# Valley of the Winds Wind Farm

## Addendum to Landscape and Visual Impact Assessment

The purpose of this Addendum Report is to provide additional information relevant to the Landscape and Visual Impact Assessment (LVIA) prepared by Moir Landscape Architecture for the Valley of the Winds Wind Farm Project (SSD-10461) referred to hereafter as ‘the Project’.

Since lodging the EIS, ACEN (the Proponent) has made amendments to the 2022 project layout (referred to as the Superseded Layout) in response to matters raised in the submissions and further agency, community and stakeholder consultation. This Addendum Report provides an updated assessment of the revised project layout (referred to as the ‘Revised Layout’).

**Figure 10. Amendments to Girragulang Road (GR) Cluster**

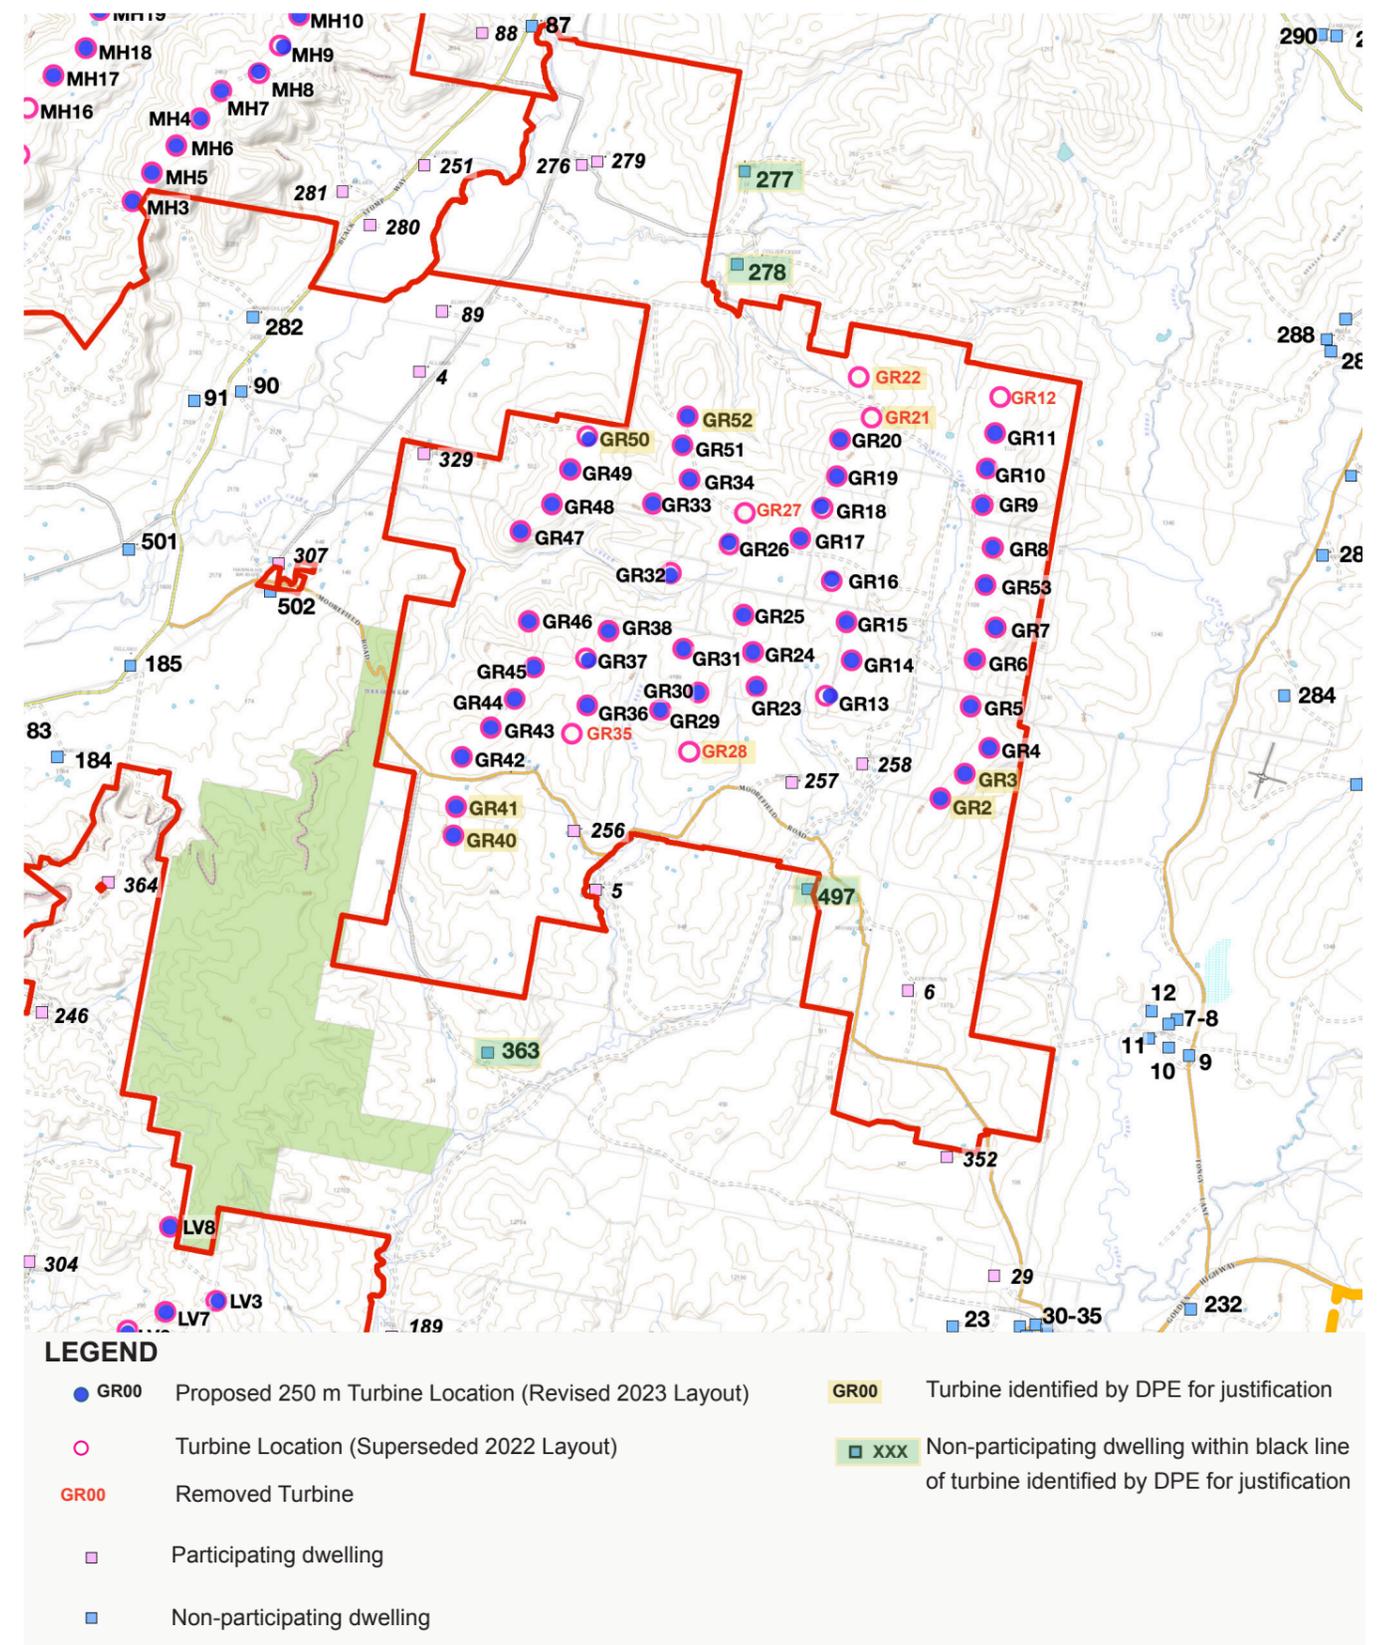
The Girragulang Cluster of turbines had a total of 51 turbines in the Superseded Layout (2022). In response to visual and biodiversity impacts and the RFI from the DPE, a total of six (6) turbines have been removed and two (2) turbines have been repositioned (refer to **Table 13**). The Girragulang Cluster has a total of 45 turbines in the Revised Layout (2023). **Figure 10** illustrates the removal and repositioning of turbines.

The DPE identified nine (9) turbines to consider and justify impacts. Three (3) of these turbines have been removed to reduce visual impacts to nearby dwellings, whilst six (6) have been retained in the Revised Layout.

Figure 11. Amendments to Leadville (LV) Cluster

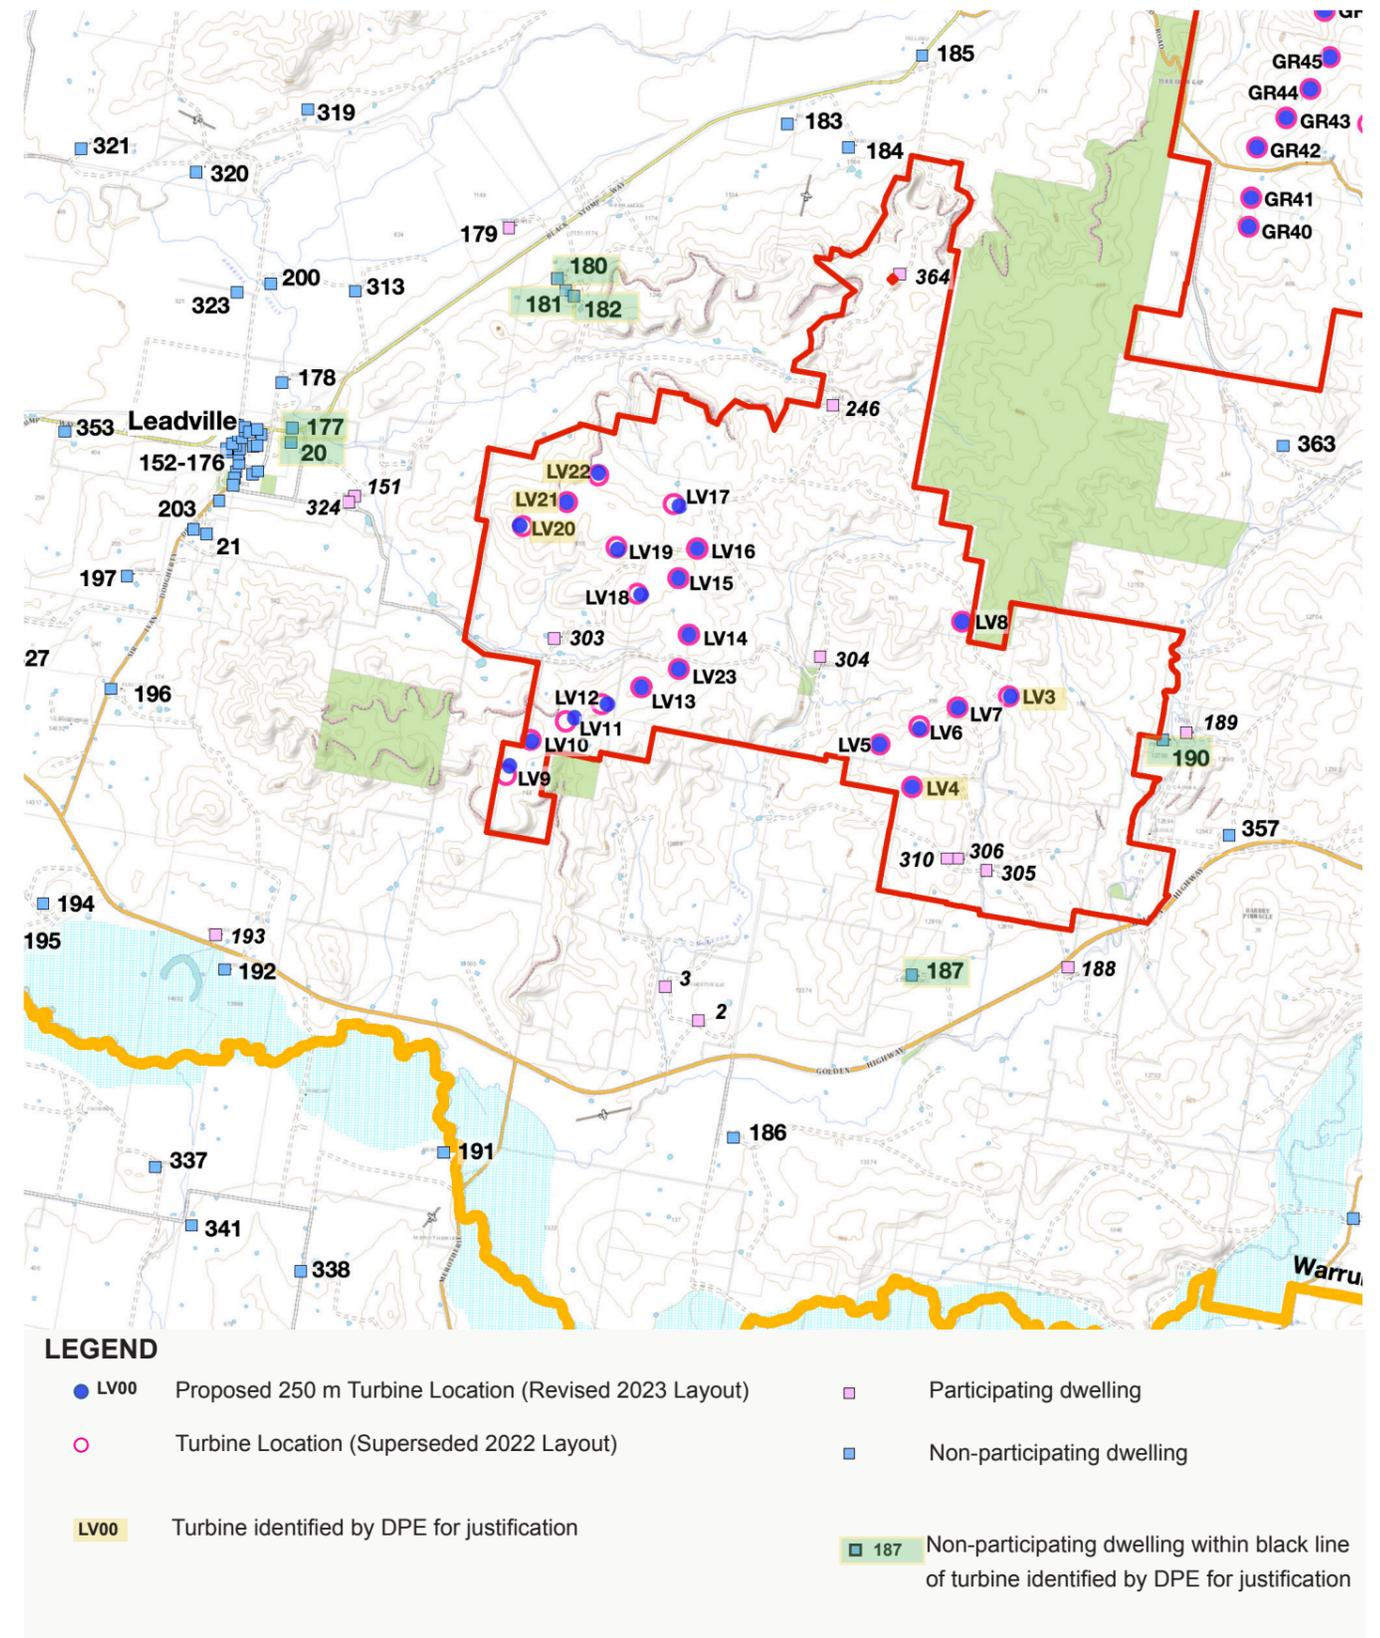
The Leadville Cluster of turbines had a total of 21 turbines in the Superseded Layout (2022). Moir LA have reviewed the turbines identified by DPE for further consideration and justification, and no turbines have been removed. Six (6) turbines have been repositioned within 150 m of the Superseded Layout location (refer to **Table 14**). The Leadville Cluster has a total of 21 turbines in the Revised Layout (2023). **Figure 11** illustrates the repositioning of turbines.

The DPE identified five (5) turbines to 'consider and justify impacts'. Moir LA have undertaken additional assessment of these turbines and all five (5) turbines have been retained in the Revised Layout.
